City of Portland, Oregon
Bureau of Development Services
Land Use Services
FROM CONCEPT TO CONSTRUCTION

NOTICE OF A TYPE II DECISION ON A PROPOSAL IN YOUR NEIGHBORHOOD

CASE FILE NUMBER: LU 15-252516 DZ
AC HOTEL - CHANGES TO TYPE III APPROVAL

Proposal:
The proposal is for the following revisions to the approved Land Use Review for the AC Hotel by Marriott (LU14-225506 DZAD) including the following elements:
1. Revise rooftop mechanical screen.

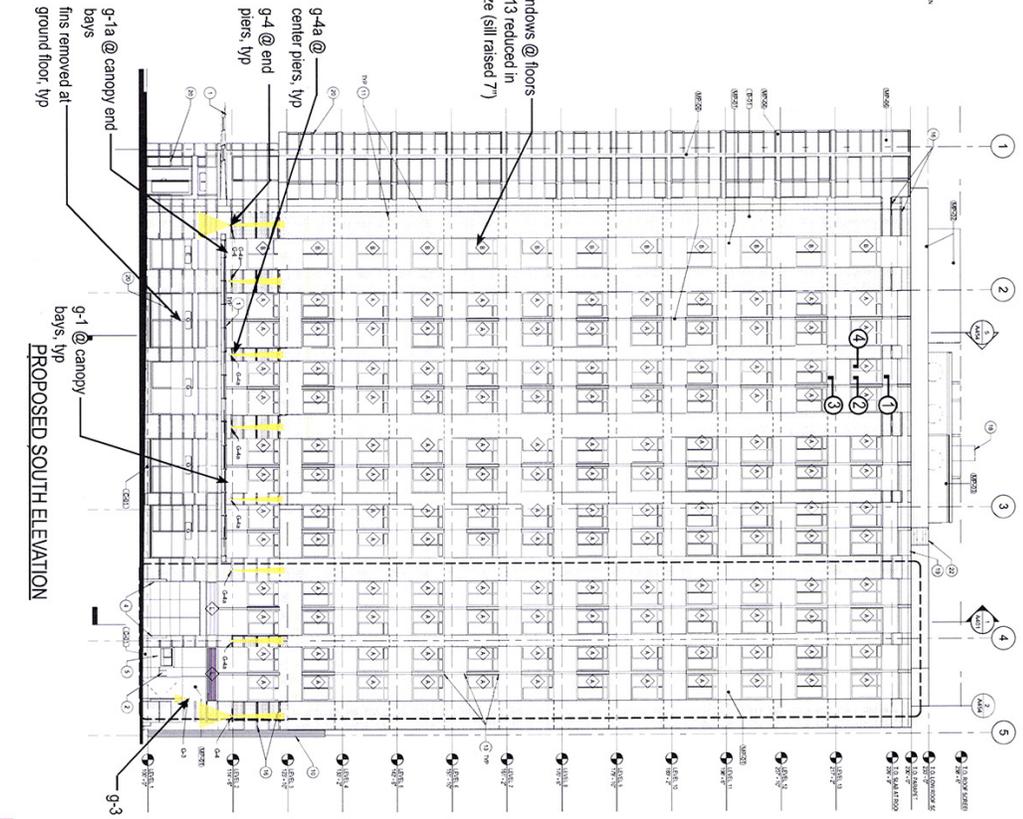
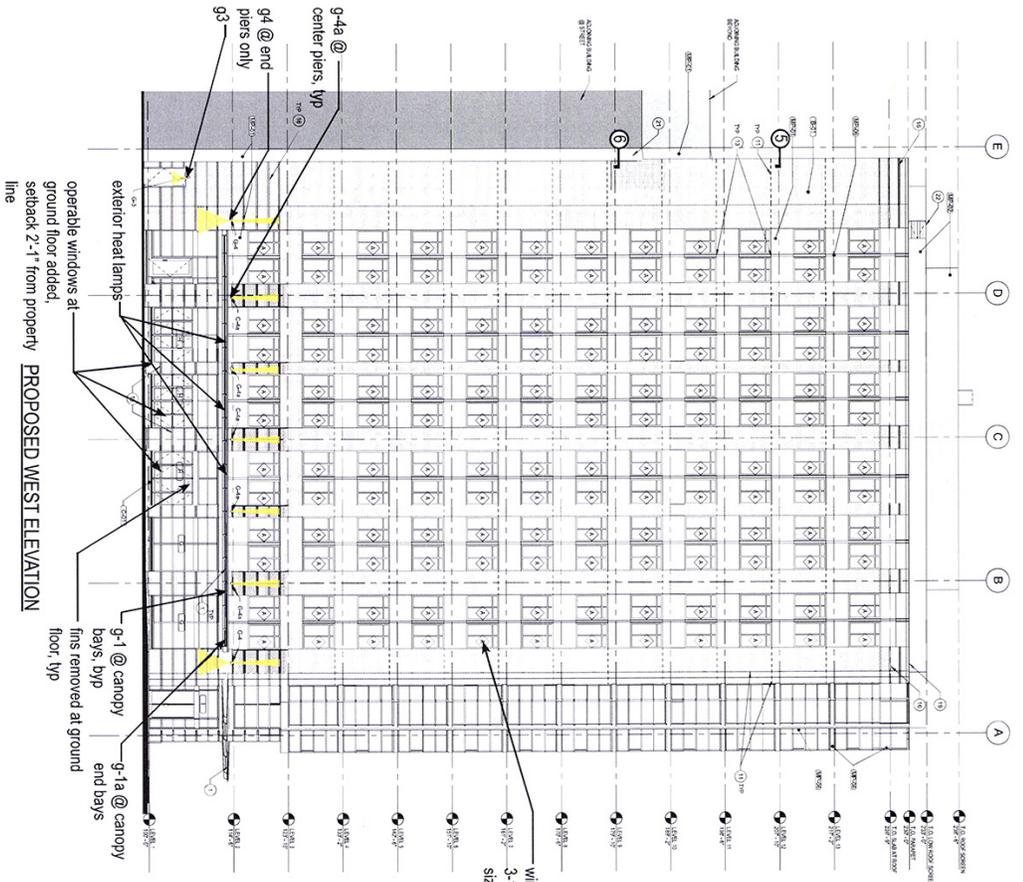
Findings for A8, B1, B2, B4, B5, B6, C9. The proposed design changes to the ground floor storefront system (glass canopy with integrated heat lamps and channel lighting, and operable windows with 1' increased recess) will help make the spill-out area for the lounge more successful with increased safety and comfort measures, and covered space thereby enhancing functionality and safety of the sidewalk for patrons.

Changes to the canopies will drain water onto the sidewalk, where they were previously approved to drain to gutters and downspouts. The canopies proposed to drain to the sidewalk are consistent with existing practices elsewhere in the Central City. The continuous canopies will still provide the same level of weather protection along the sidewalk as approved.

The proposed relocation of the gas meter from the west elevation (near the lounge spill-out area) to the south elevation (near the loading bay) will improve seating ambience without impacting loading operations.

Findings for C12. The exterior lighting revisions are limited to the ground level along the west and south elevations where they serve the purpose of enhancing ambient lighting at the lounge spill-out area and upward illumination of the pilasters. Both interventions will enhance ground level functionality while serving to subtly highlight the building’s architecture.

PROPOSED EAST ELEVATION

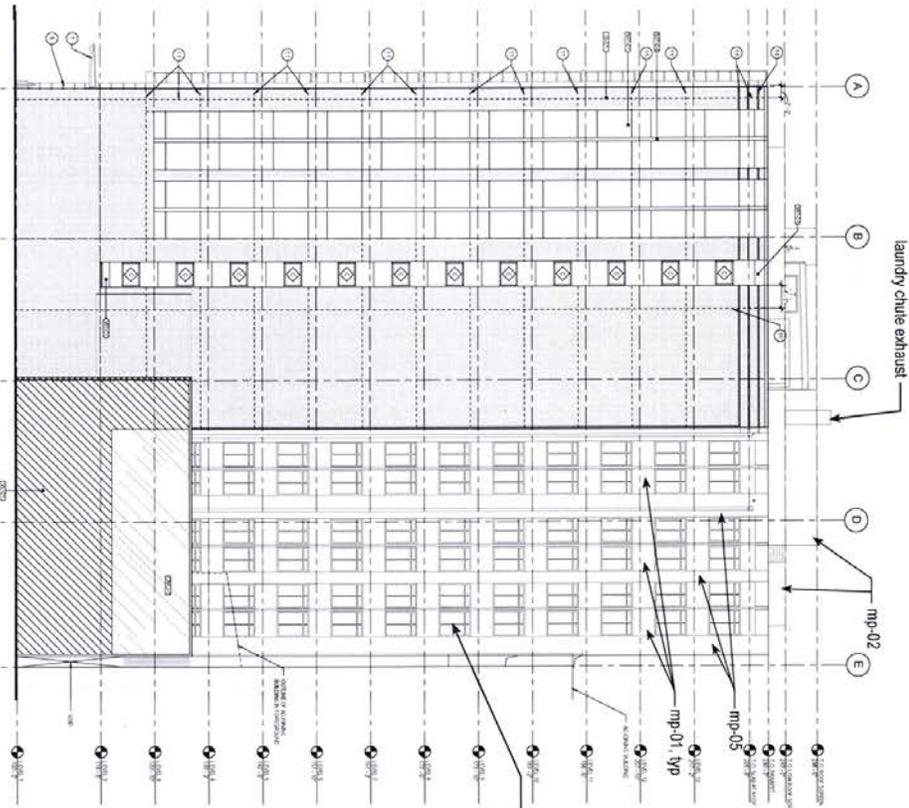
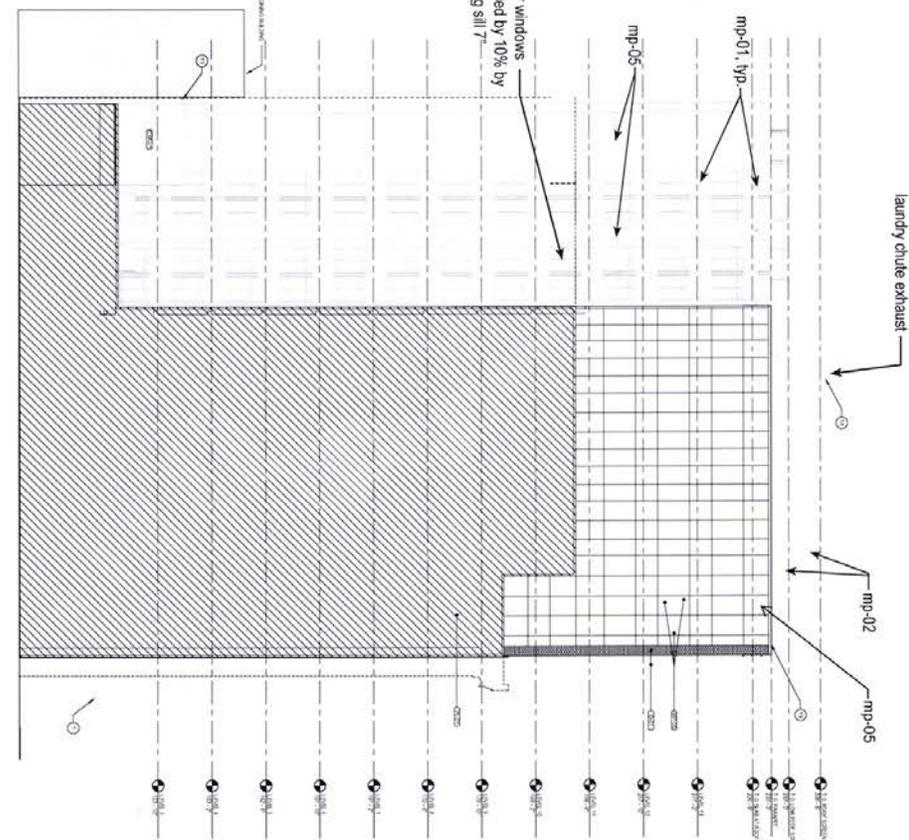
The replacement of brick with white aluminum composite panel at the north and east elevations facing the 2nd level roof (interior facing end wall conditions) will not significantly alter the building's overall coherency as all street-facing facades will remain white brick. The proposed metal replacement is intended to match (color and

gage) material previously approved elsewhere on the building (accent on west and south elevations and rooftop mechanical screening.) As this material is interior to the block with limited oblique views from public space and is already used at other locations on the building, this change will not significantly lessen the coherency or permanence of the building.

Findings for C11. The second level rooftop changes – relocation of stormwater planter from the building’s perimeter to interior, relocation of the generator enclosure from the center of the roof to the east building wall – will better conceal rooftop equipment from limited interior block views.
